TOWN OF PALM BEACH
Planning, Zoning & Building Department
360 South County Road
Palm Beach, FL 33480
www.townofpalmbeach.com

PLANNING, ZONING, & BUILDING DEPARTMENT
PZ&B Staff Combination Memorandum: Architectural Commission and Town Council

SUBJECT: ARC-24-0080 (ZON-24-0042) 141 ATLANTIC AVE (COMBO)

MEETING: DECEMBER 20, 2024 ARCOM
JANUARY 15, 2025 TC

CURRENTLY PROPOSED FRONT AND SOUTH ELEVATION

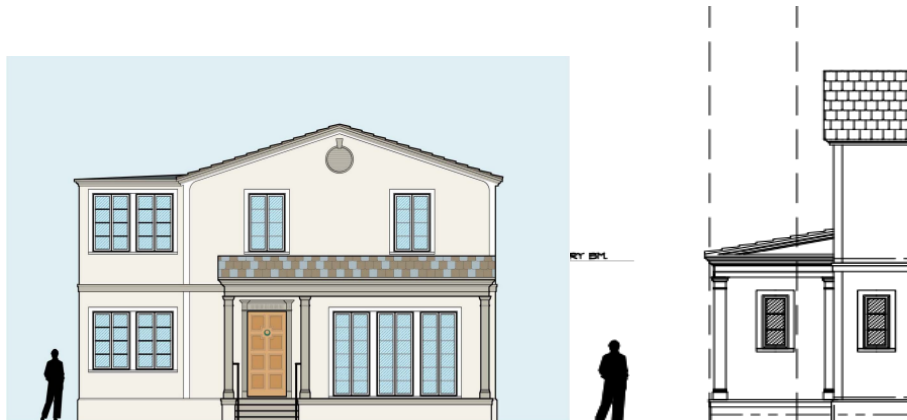
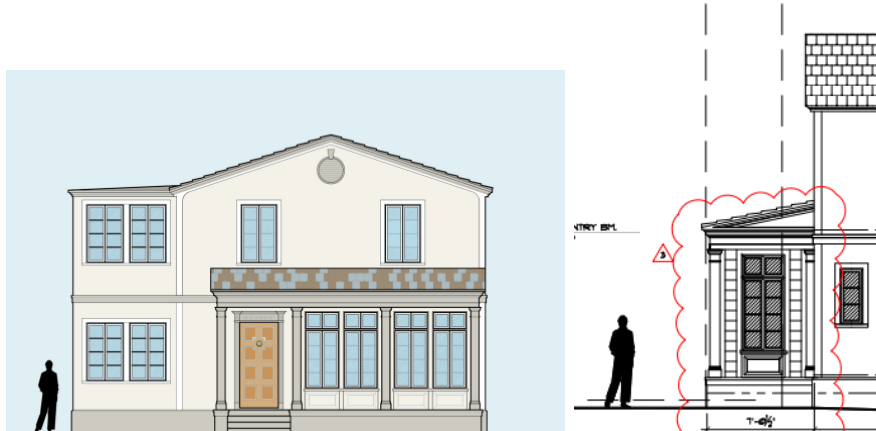
The application was first heard at the November 22, 2024 meeting. The item was deferred with a (7-0) vote with the direction to restudy the proposed first floor addition. The application is for the removal of an existing front porch of a single-family residence to allow for a first-floor expansion of approximately 110 SF. The addition will create additional living room space and present a new covered entry to the existing front door. Following the November deferral the applicant has revised the windows and transom configuration to include raised wood panels, and added a pilaster.

SCHEMATIC PROPOSED LANDSCAPE OPEN SPACE

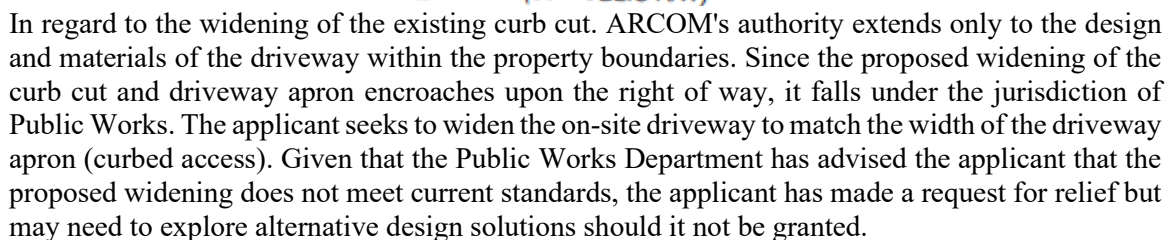
As part of the landscape and site improvements to the front of the property, the applicant is also seeking a new driveway configuration. Specifically, expanding the driveway width from 14'-0" to 17'-0".
